**THE KENNECOTT EAGLE
MINE PLANNED FOR
UPPER
MICHIGAN IS PREDICTED
TO BE
UNSTABLE.**

JACK PARKER AND ASSOCIATES, INC.

The Kennecott Eagle Project

THE KENNECOTT EAGLE PROJECT APPLICATION FOR PERMITS TO MINE IS REplete WITH ERRORS AND OMISSIONS; BUT, MOST SIGNIFICANTLY, WHEN A VERY FEW OF THE ERRORS ARE CORRECTED THE KEMC CONCLUSIONS ARE REVERSED AND THE MINE AND THE CROWN PILLAR ARE PREDICTED TO BE

Figure 1

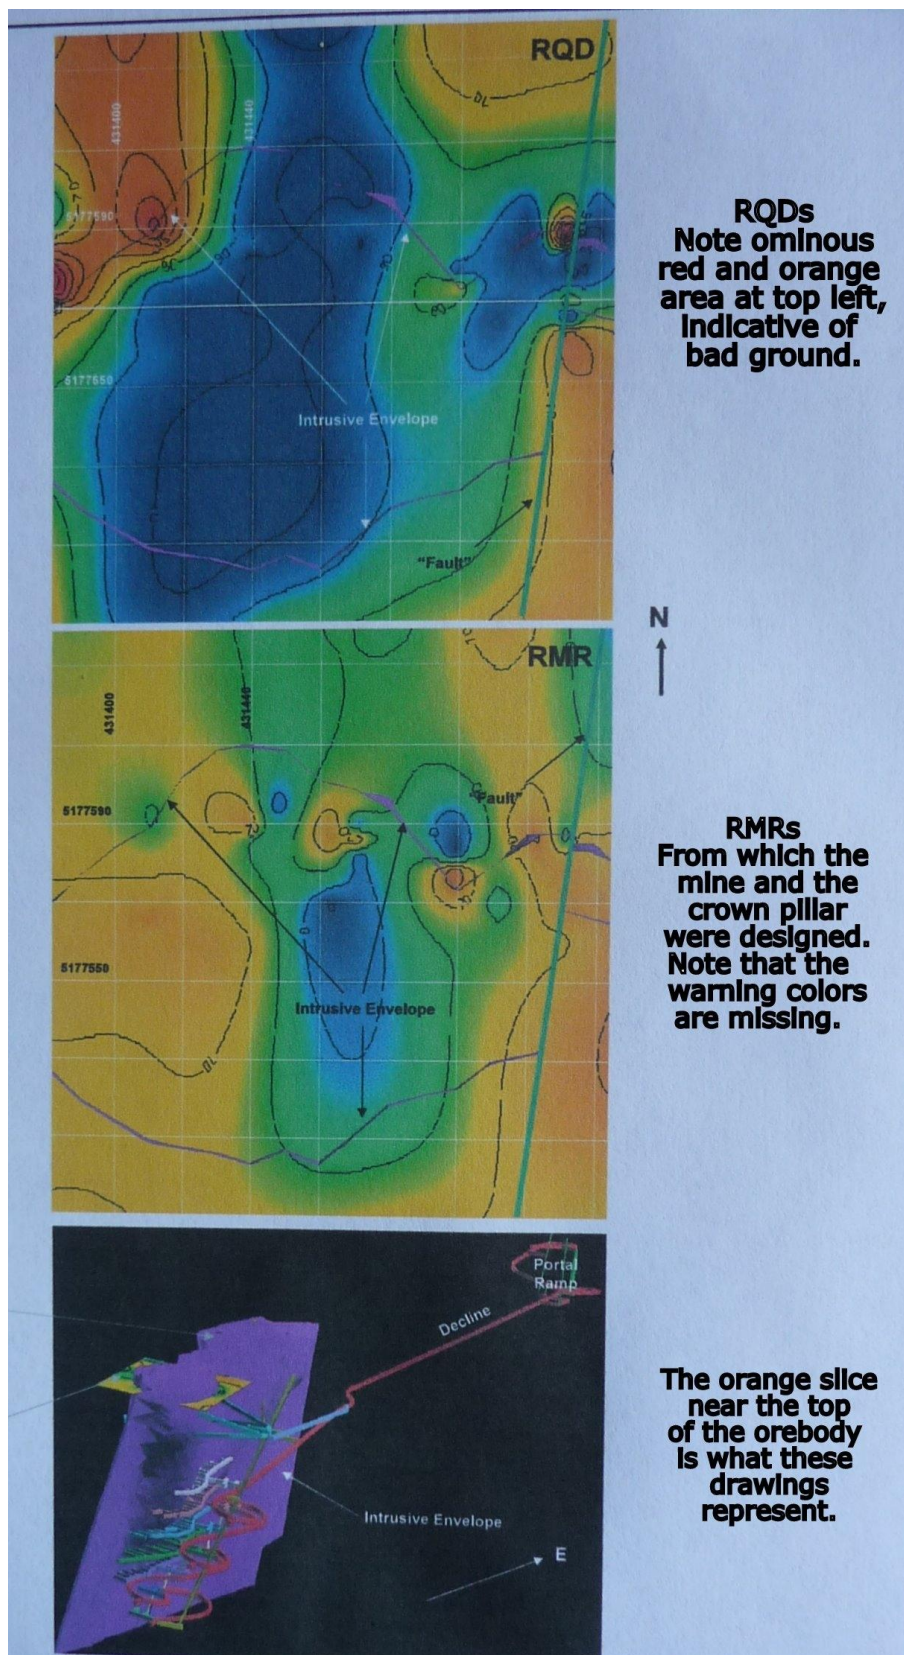
DRAWINGS COMPARING RQDs AND RMRs. Figure 1 is an example. Tabulated values were transferred to drawings at the location of the drill holes. Contours (lines of equal value) were then interpolated between holes. Then the areas between contours were color-coded, from red to show poorest conditions to green and blue showing the best.

Note immediately that the contours around the red holes are close together – “bull’s-eyes” – implying that their influence is local, not widespread. The contours between blue/green holes are far apart, implying that the good conditions *are* widespread. That, of course, skews the information toward favorable conditions.

Figure 1 illustrates the point. It represents conditions on a horizontal slice through the ore body, roughly in the middle of the ore body (see lower sketch).

At top left in the upper drawing, RQDs, is a large ominous patch of reds and oranges. This is appropriate, because the cores there are broken and the RQDs are low. Look again at the front cover of this report. Does that look like “solid rock”?

But now look at the middle drawing, RMRs. That ominous red/orange patch does not show up!

Hey! We, like everybody else, had assumed that we were being fed sound engineering information; but now we smell a rat. Existence of the rat was confirmed when we obtained a tabulation of RQDs and RMRs for “our” eight holes. **THE LOW RQD VALUES WERE ON RECORD, BUT CORRESPONDING RMRs WERE MISSING. THOSE LENGTHS OF POOR CORE HAD BEEN OMITTED AS IF THEY DID NOT EXIST. MINE PLANNERS, REGULATORS AND OUTSIDE REVIEWERS ALIKE DID NOT NOTICE THE DECEPTION. It is subtle and clever, although not especially smart.**

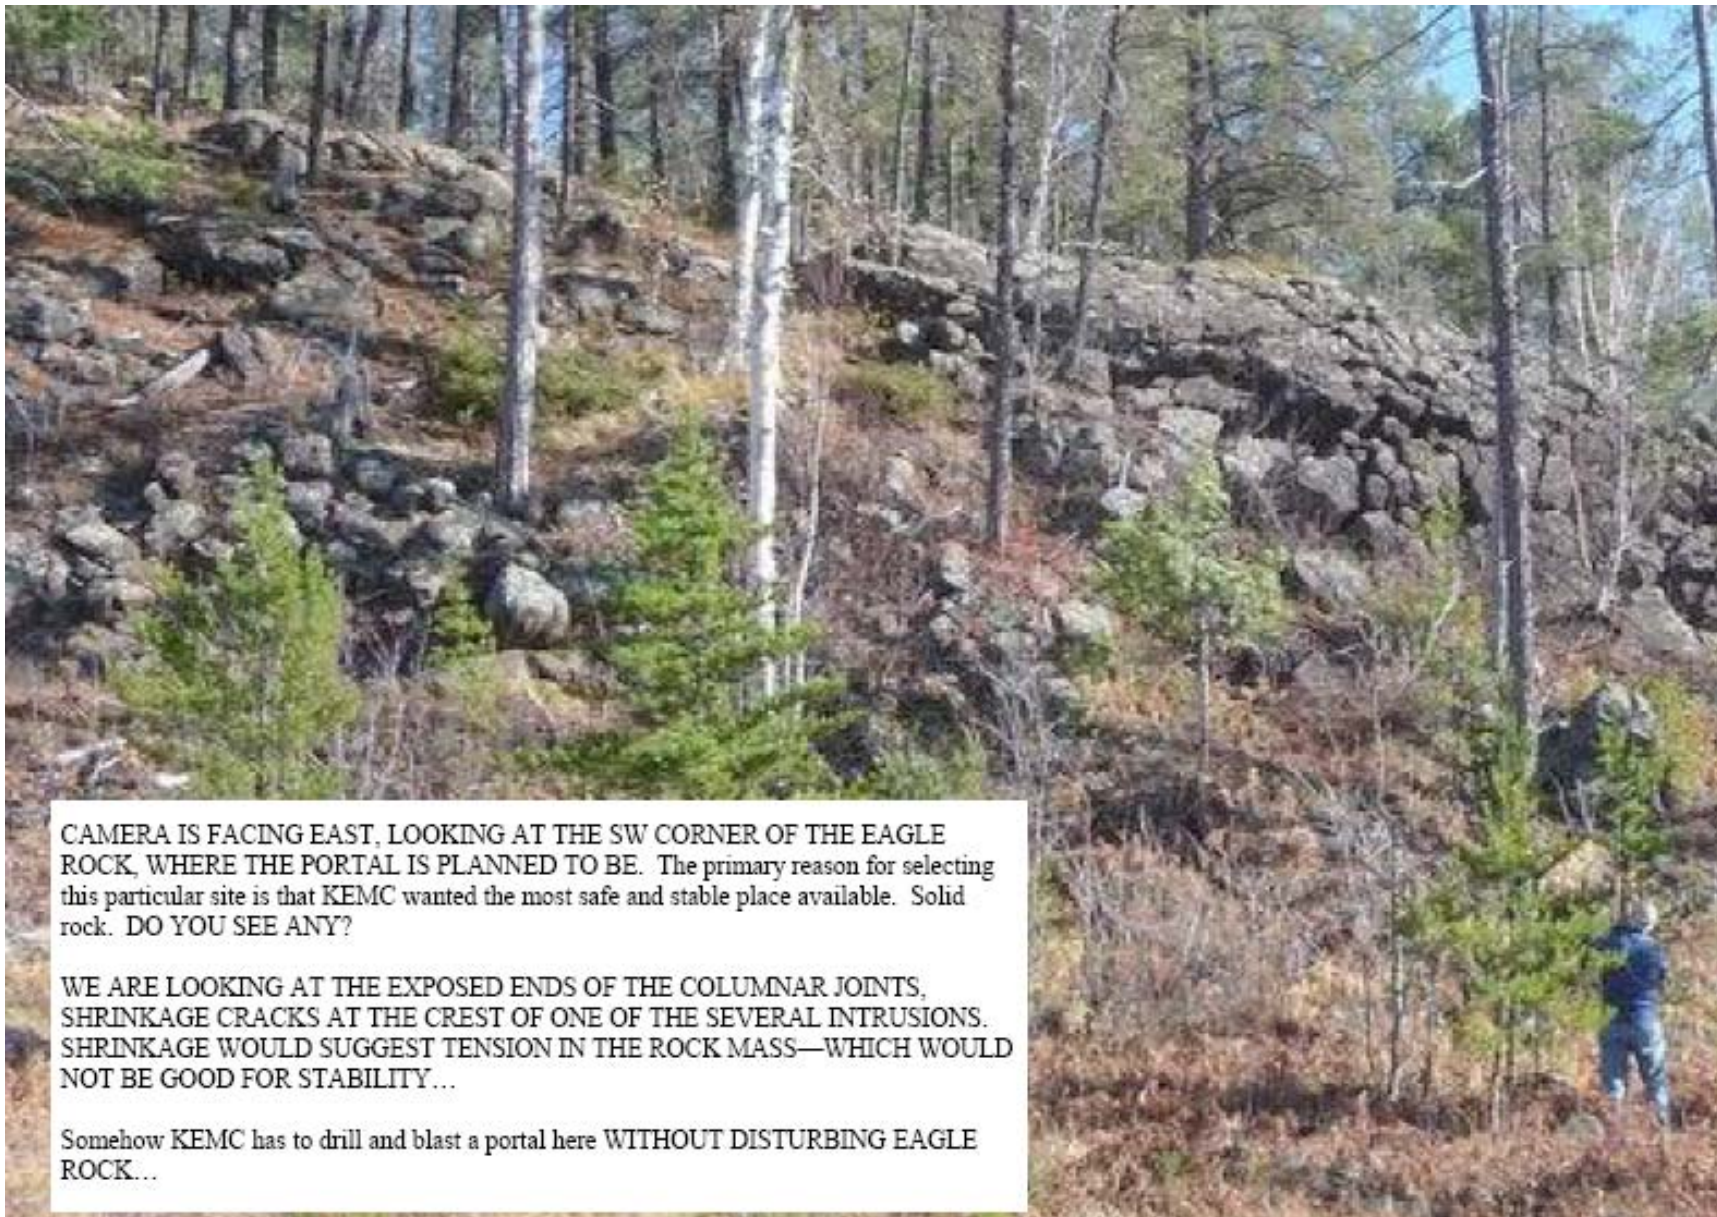
CAMERA IS FACING EAST, LOOKING AT THE SW CORNER OF THE EAGLE ROCK, WHERE THE PORTAL IS PLANNED TO BE. The primary reason for selecting this particular site is that KEMC wanted the most safe and stable place available. Solid rock. DO YOU SEE ANY?

WE ARE LOOKING AT THE EXPOSED ENDS OF THE COLUMNAR JOINTS, SHRINKAGE CRACKS AT THE CREST OF ONE OF THE SEVERAL INTRUSIONS. SHRINKAGE WOULD SUGGEST TENSION IN THE ROCK MASS—WHICH WOULD NOT BE GOOD FOR STABILITY...

Somehow KEMC has to drill and blast a portal here WITHOUT DISTURBING EAGLE ROCK...
